Order No. EA-12-049

RS-14-209

LaSalle County Station, Units 1 and 2
Facility Operating License Nos. NPF-11 and NPF-18
NRC Docket Nos. 50-373 and 50-374

Subject: Third Six-Month Status Report in Response to March 12, 2012 Commission Order
Modifying Licenses with Regard to Requirements for Mitigation Strategies for Beyond-
Design-Basis External Events (Order Number EA-12-049)

MAAP Calculation of RPV Pressure During RPV Depressurization

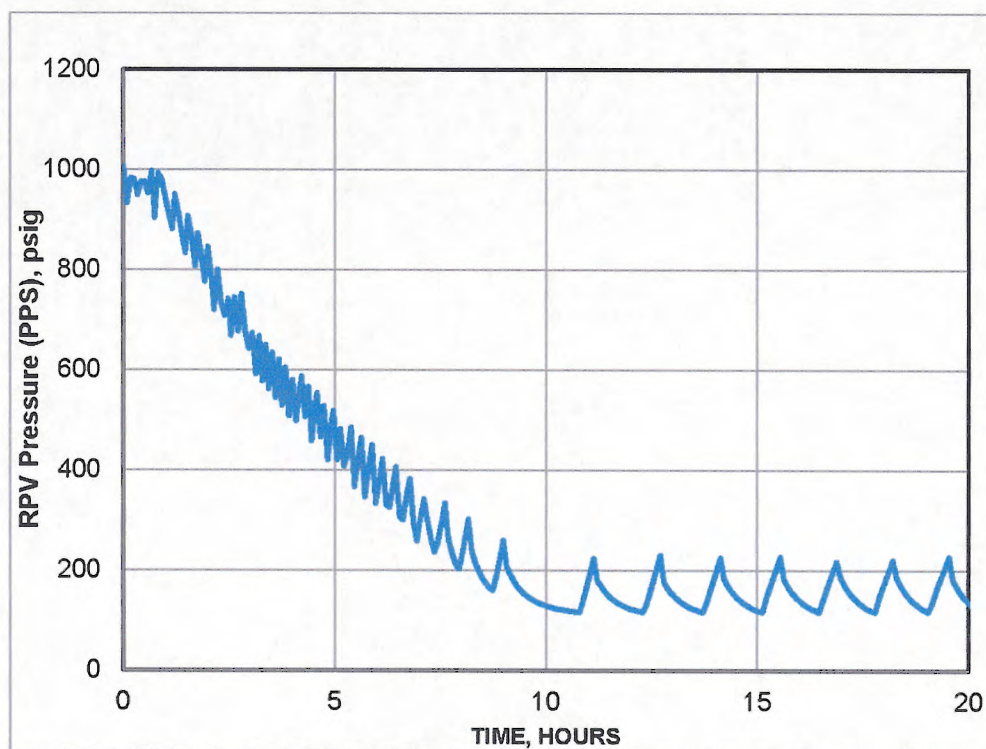
Question 2

The collapsed level must remain above Top of Active Fuel (TAF) and the cool down rate must be within Technical Specification limits.

Attachment 1A of the LaSalle Integrated Plan (Feb. 2013) states that the operators would commence a cooldown of the RPV at 20 min at a rate of 20°F/hr which is within the Technical Specifications limit of 100°F/hr. The following plot of the RPV pressure from the MAAP4 analysis confirms this cooldown rate for the supporting MAAP4 calculation was modeled correctly.

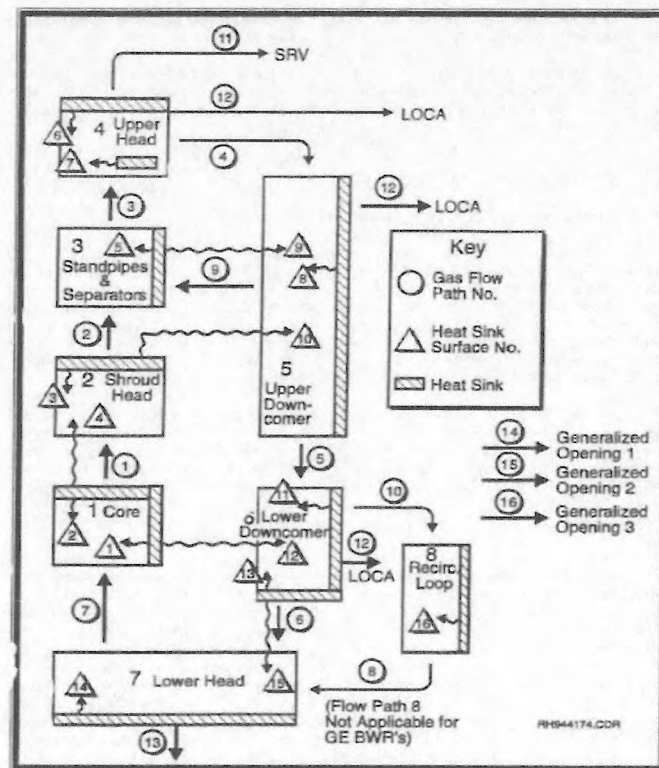
In using MAAP4, the licensee must identify and justify the subset of key modeling parameters cited from Tables 4-1 through 4-6 of the "MAAP4 Application Guidance, Desktop Reference for Using MAAP4 Software, Revision 2" (Electric Power Research Institute Report 1020236) [4]. This should include response at a plant-specific level regarding specific coding options and parameter choices for key models that would be expected to substantially affect the ELAP analysis performed for that licensee's plant. Although some suggested key phenomena are identified below, other parameters considered important in the simulation of the ELAP event by the vendor / licensee should also be included.

- a. Nodalization
- b. General two-phase flow modeling
- c. Modeling of heat transfer and losses
- d. Choked flow
- e. Vent line pressure losses
- f. Decay heat (fission products / actinides / etc.)

- a. The reactor vessel nodalization is fixed by the MAAP code and cannot be altered by the user, with the exception of the detailed core nodalization. The LaSalle MAAP 4.0.5 Parameter File divides the core region into 5 equal volume radial regions and 13 axial regions. The axial nodalization represents 10 equal-sized fueled nodes, 1 unfueled node at the top, and 2 unfueled nodes at the bottom. The LaSalle MAAP 4.0.5 Parameter File is documented in LS-PSA-009, Rev. 2 [5]. The figure below, taken from the MAAP Users Manual, illustrates the vessel nodalization scheme.
